3705 77<sup>th</sup> PI SE (Mercer Island) August 8, 2022 Page **1** of **2**

Provide tree inventory and site details to meet development requirements.

PARCEL #5458800550 ZONING: R-8.4

JOB NO: 21006 DATE: 6/13/22 DRWN. BY: TH REVISED: 9/8/22

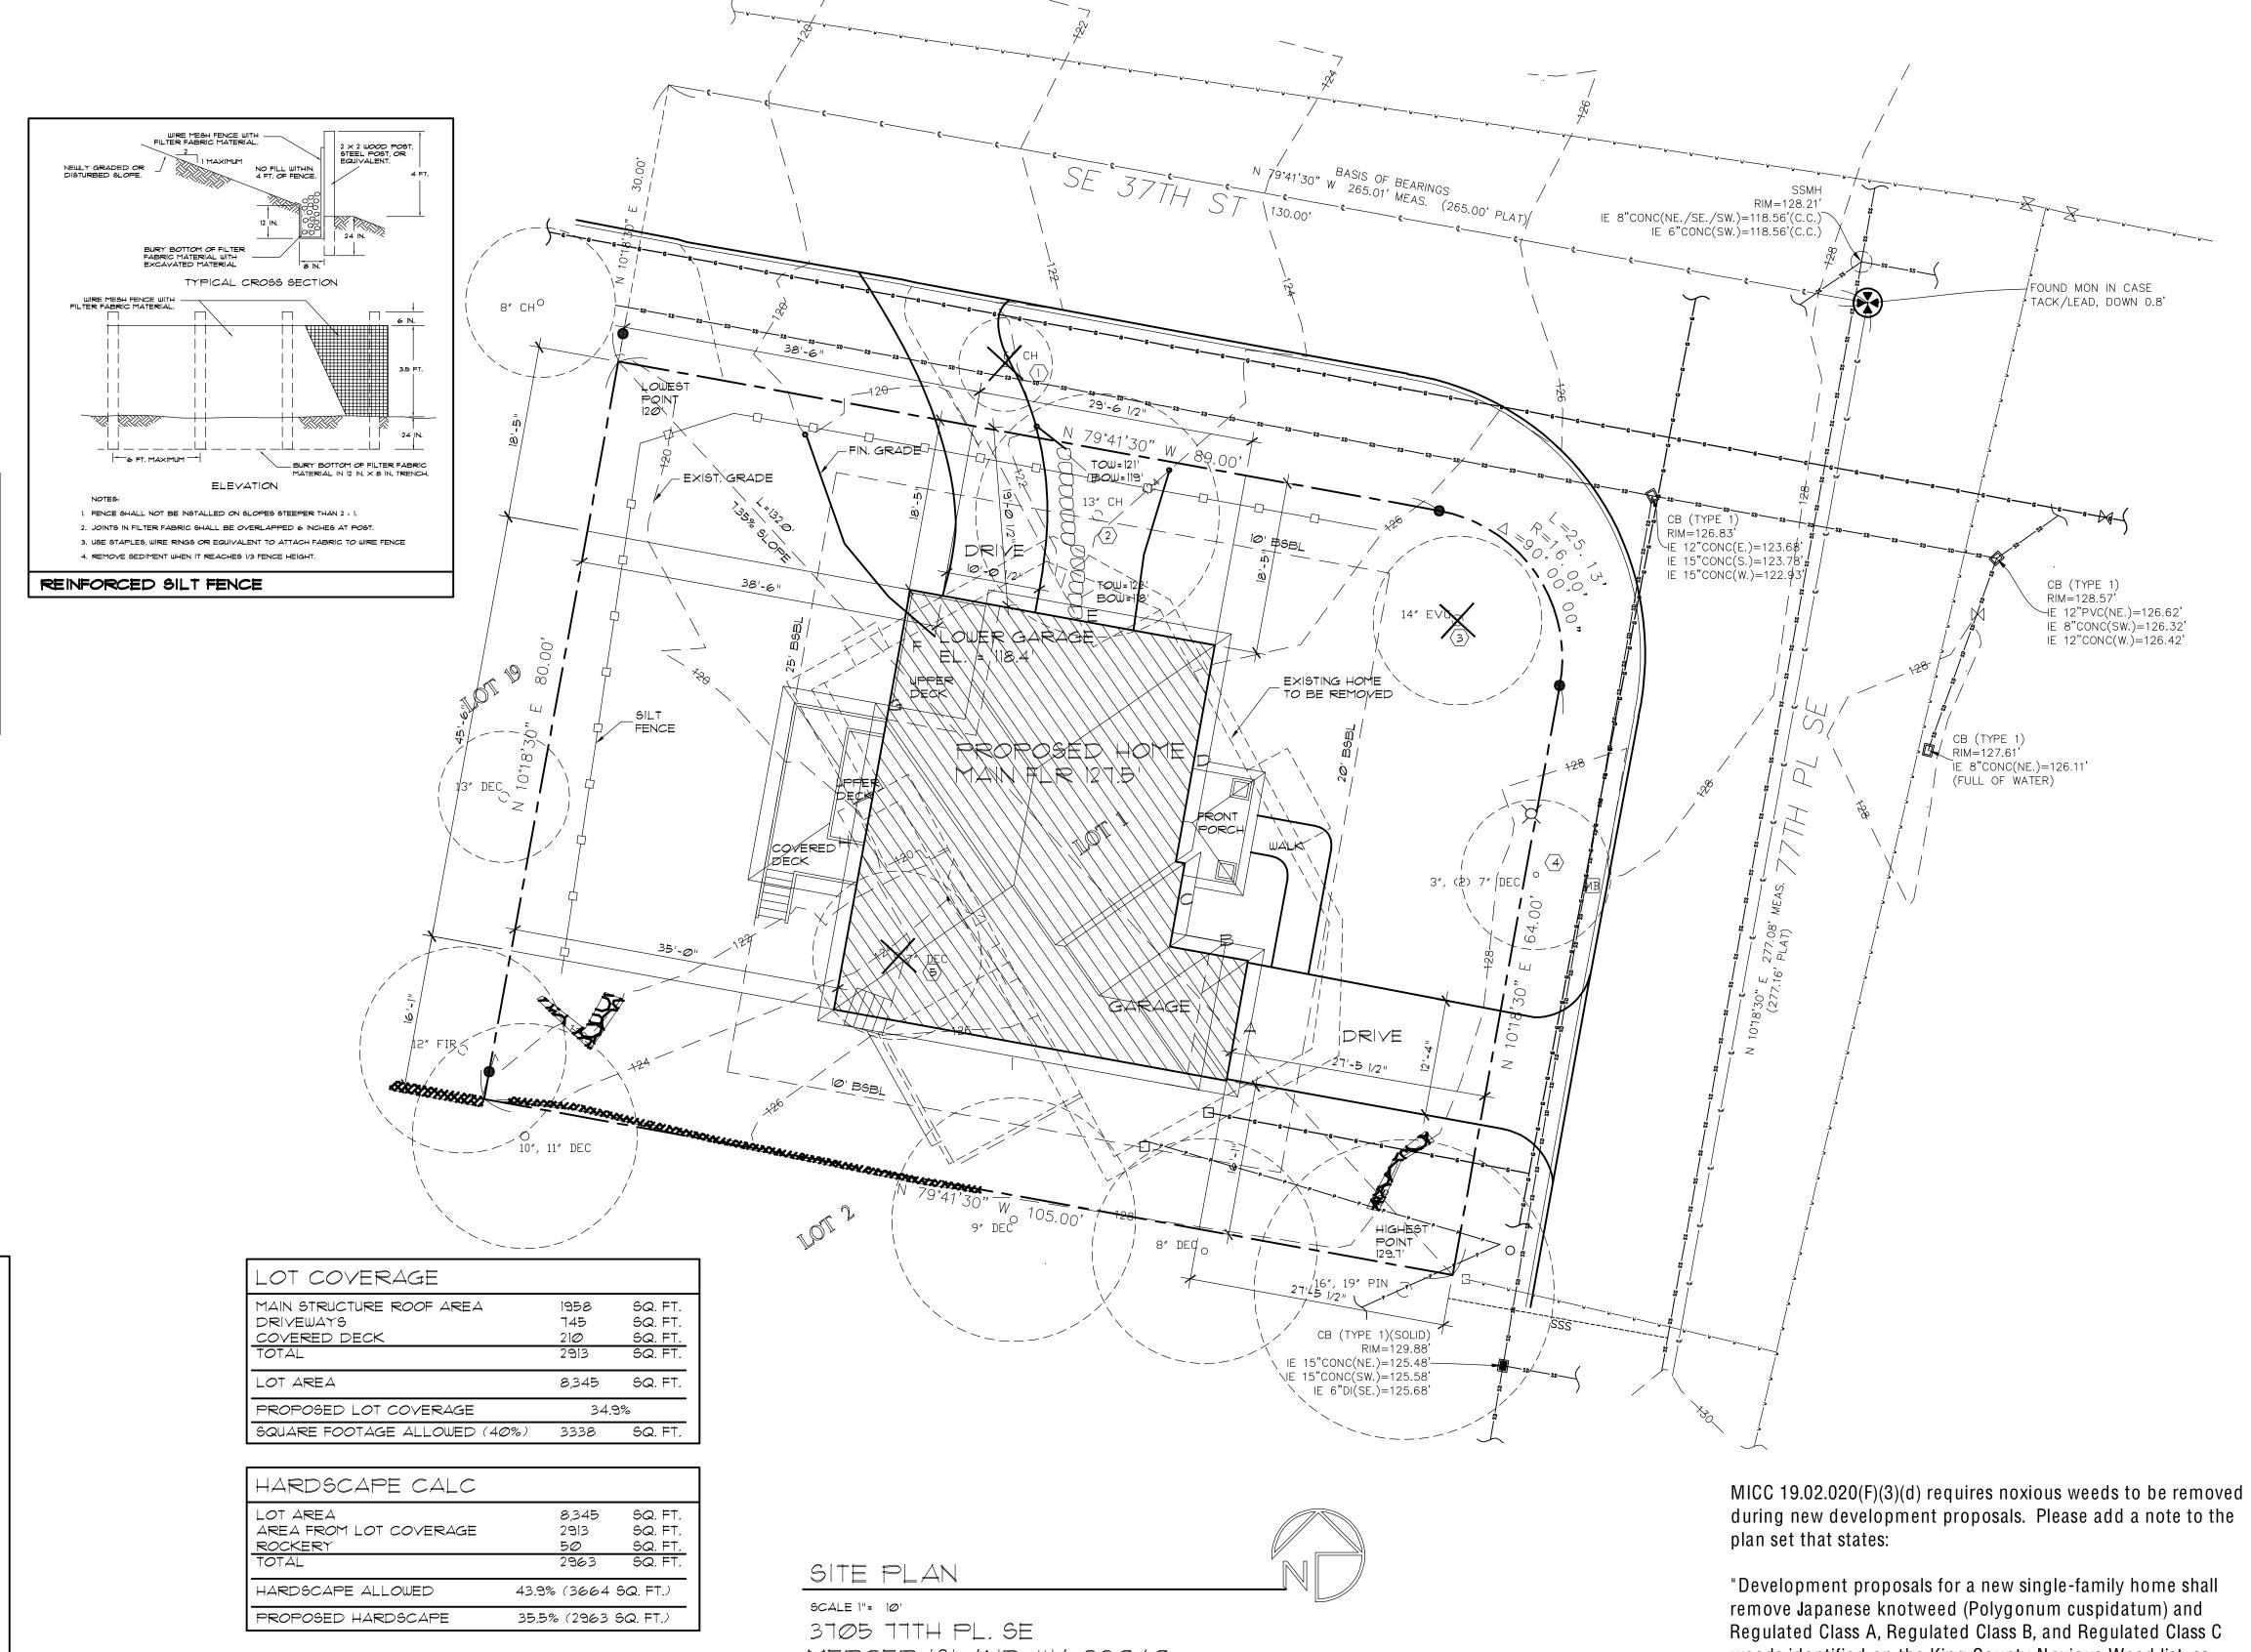
Pursuant to MICC 19.02.050(D) any "...rockeries, retaining walls, fences, or any combination thereof, are limited to a maximum height of 42 inches within that portion of any required yard which lies within 20 fee of any improved street." Please indicate the height of the rock wall that falls within 20 feet of the public-right-of way.

If the height exceeds the 42-inch height limitation you can apply for a fence height deviation pursuant to MICC 19.02.050(F).

Fence height deviation required for 4' retaining walls.
